CORRIGENDUM - 12

E- Tender No.: SJVN/CHQ/ECD/SUNNI/EMP/2024

Name of Tender: Electro-Mechanical Works of Sunni Dam HEP (382 MW) located in Distt. Shimla and Mandi in Himachal Pradesh (India).

AMENDMENT-IV

SJVN LIMITED		
सुन्नी डेम जल विद्युत परियोजना SUNNI DAM HYDRO ELECTRIC PROJECT		
MAIN SINGLE LINE DIAGRAM		
DSGN.	CHKD.	RECM.
DRWN.	RECM.	APPD.
ELECT. DESIGN DEPTT. SJVN LTD.		
DRG.NO. SJVN/ED/SDHEP/EM/12		MAR, 2025 REV-01

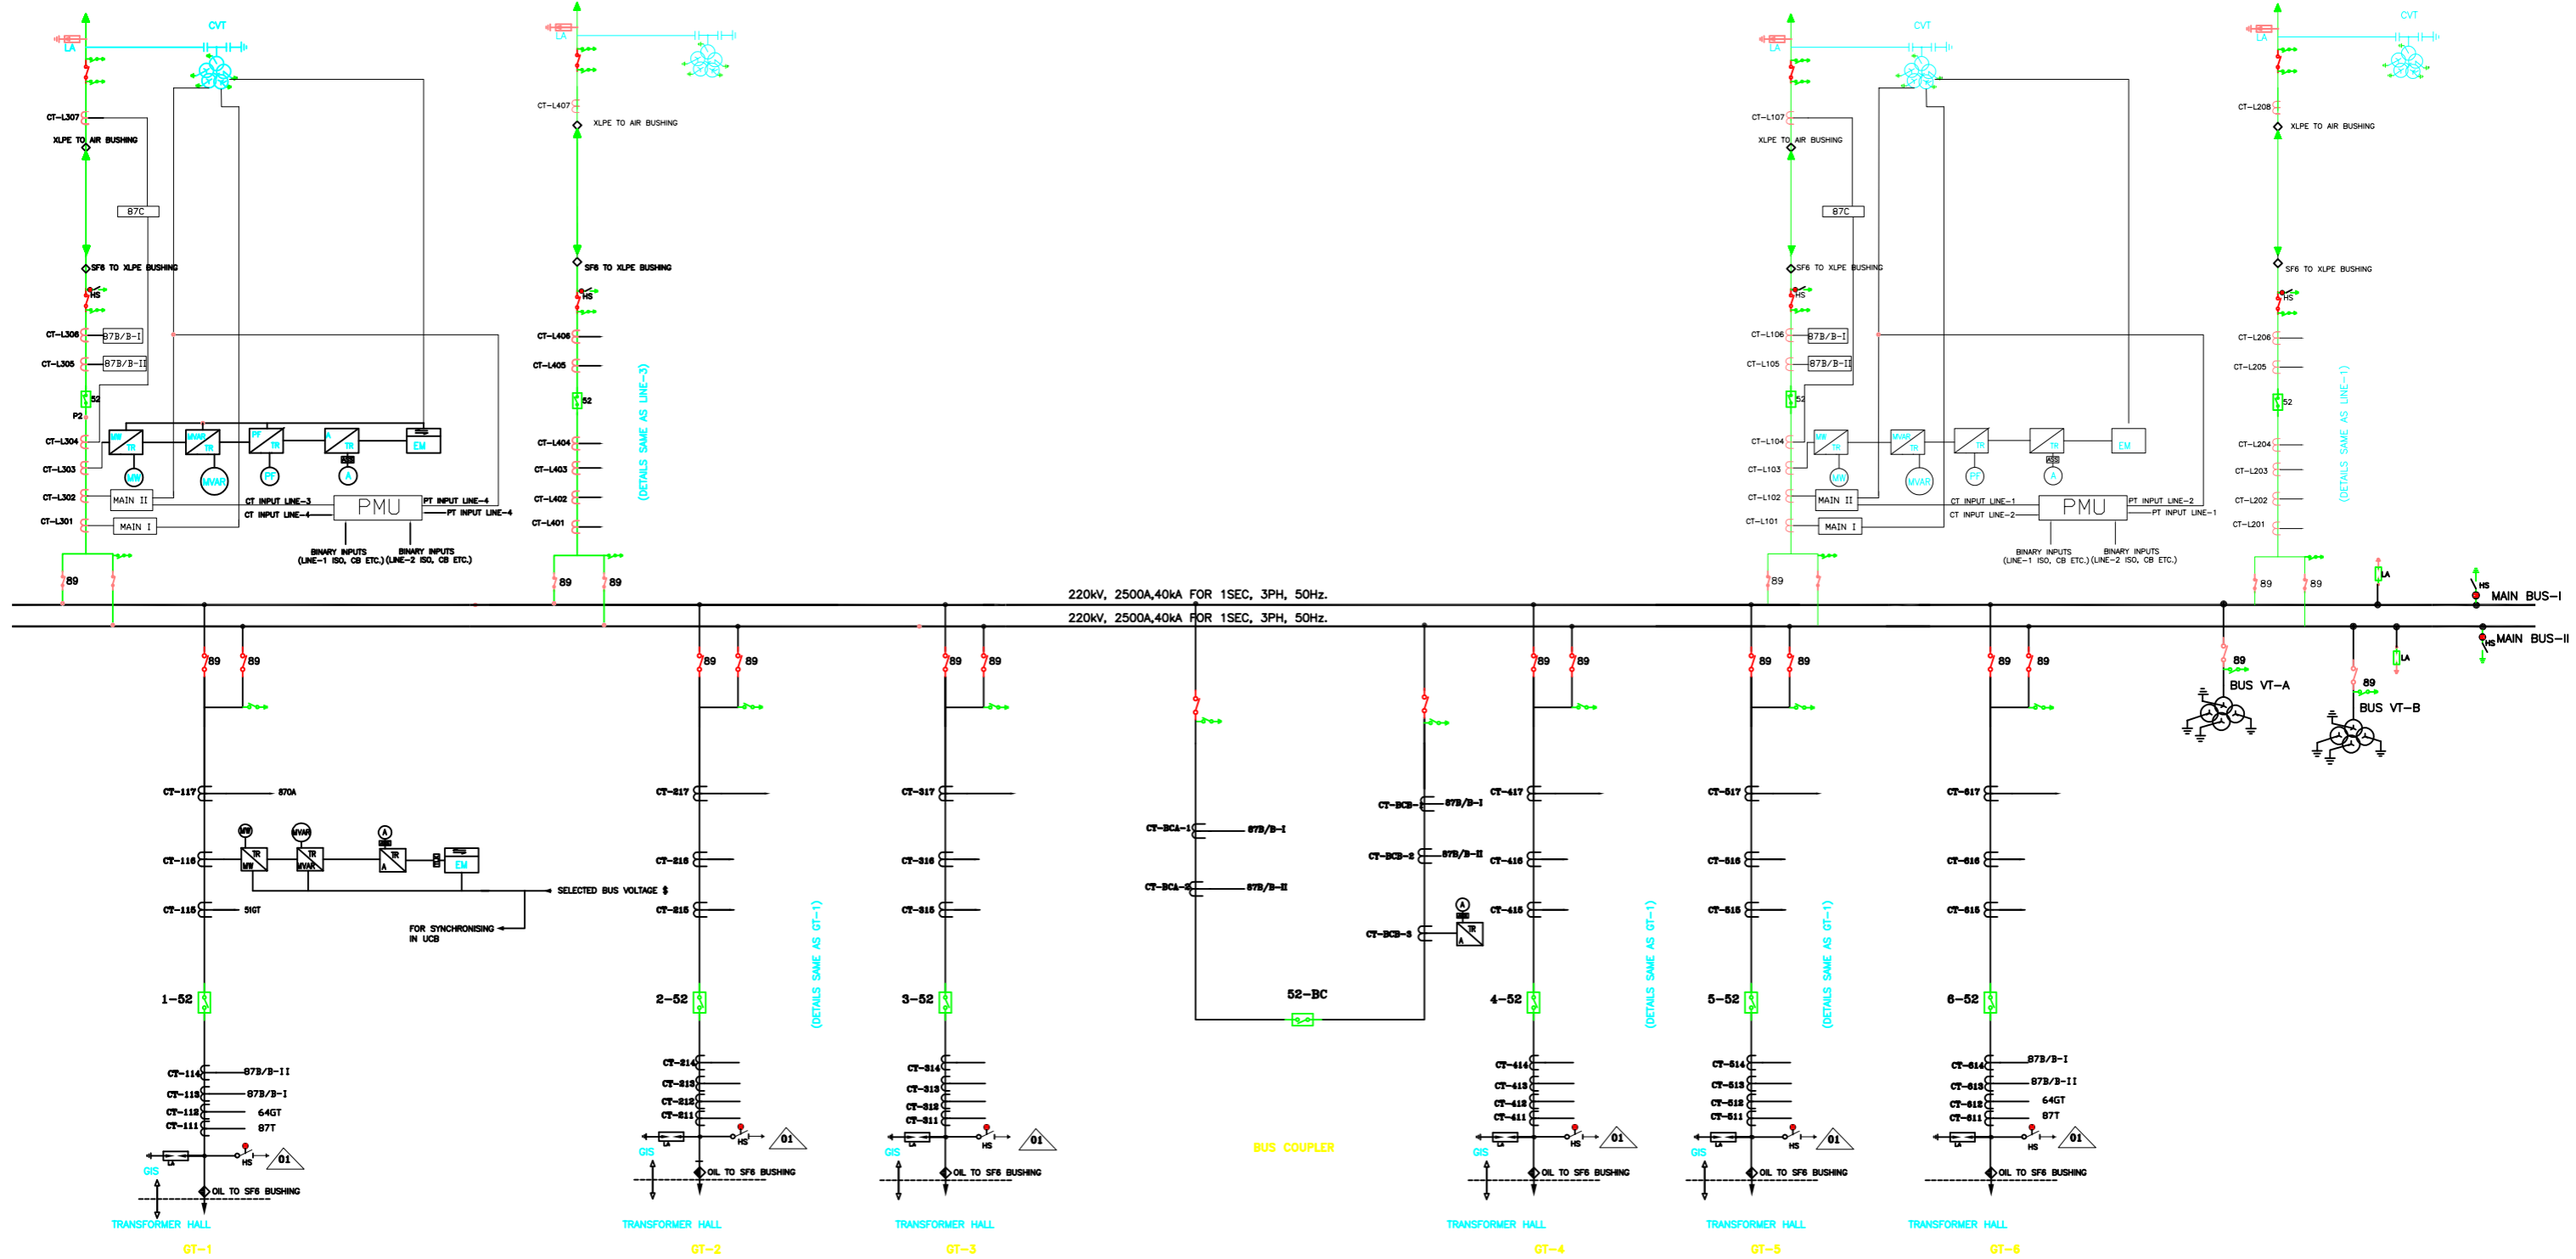
Sr. No.	Page No.	Chapter No.	Clause No.	Bidders Queries	Original Tender Provision	Amended Tender Provision
1		Gas Insulated Switchgear	Clause 16.1.1.2-a-v) & Clause 16.1.1.2-b-v)	We propose to review the requirement of high-speed fault making grounding switch. In our view, group operated safety grounding switch shall be the requirement. Please confirm.	One (01) Set -three phase high speed fault making grounding switch, complete with group operated manual and motor driven operating mechanisms.	Provision of High Speed Switch also incorporated in Main SLD. Please refer amended SLD Drawing no SJVN/ED/SDHEP/EM/12
